SUBJECT: ISSUANCE OF AMENDMENT NO.179 TO FACILITY OPERATING LICENSE
 NO. DPR-35, PILGRIM NUCLEAR POWER STATION (TAC NO. M95277)

AMENDMENT NO. 179 TO FACILITY OPERATING LICENSE NO. DPR-35 - PILGRIM
NUCLEAR POWER STATION

Amendment No. 179
License No. DPR-35

ATTACHMENT TO LICENSE AMENDMENT NO. 179

FIGURE 1
ALTERNATE AC (AAC) CONFIGURATION
NON CLASS IE DIESEL GENERATOR

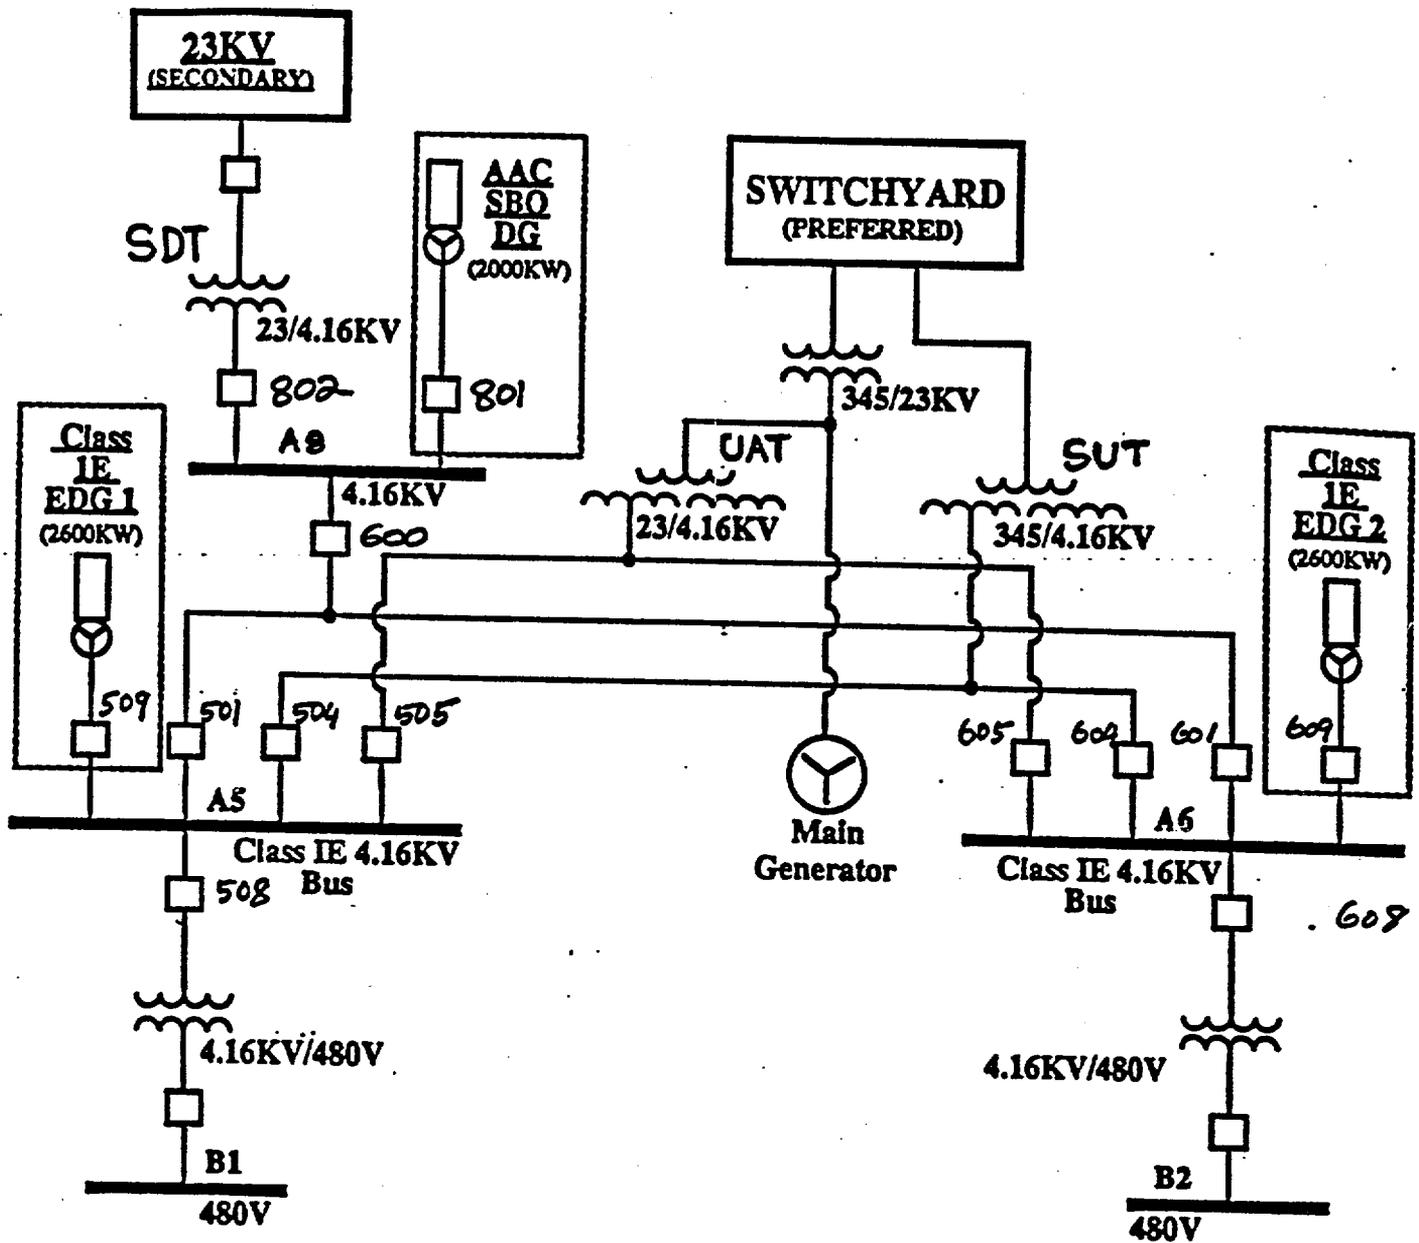
The staff expressed concern regarding the operability of the SBO-DG 1 hour after the loss of offsite power, since the auxiliaries of the SBO-DG are fed from the offsite power. The event described in Licensee Event Report (LER) 97-004-00, "Loss of Preferred Power and Oil Spill Due to Main Transformer Fault While Shutdown," included a failure of the SBO-DG to start. As a result, the licensee (1) implemented procedural enhancement to provide guidance to operators regarding startup and operation of the SBO-DG unloaded, and (2) completed a plant design change, PDC 97-14, "Revised Power Supply for SBO Diesel Auxiliaries," to provide an alternate source of power to the SBO-DG auxiliaries to ensure startup and availability of the SBO-DG during partial or degraded offsite power conditions. The SBO-DG auxiliaries will require approximately 58 kW. The alternate source of power will be provided from the 400 kW security diesel generator. The current loading on the security DG is approximately 256 kW and there is a sufficient margin to add the extra 58 kW without challenging the security diesel rating.

has been modified to require once every 8 hours, verify normal breaker configuration. Modifying the surveillance in this manner assures the breakers are configured so the SBO-DG is capable of being connected to a safety bus without interrupting the normal function of the shutdown transformer.
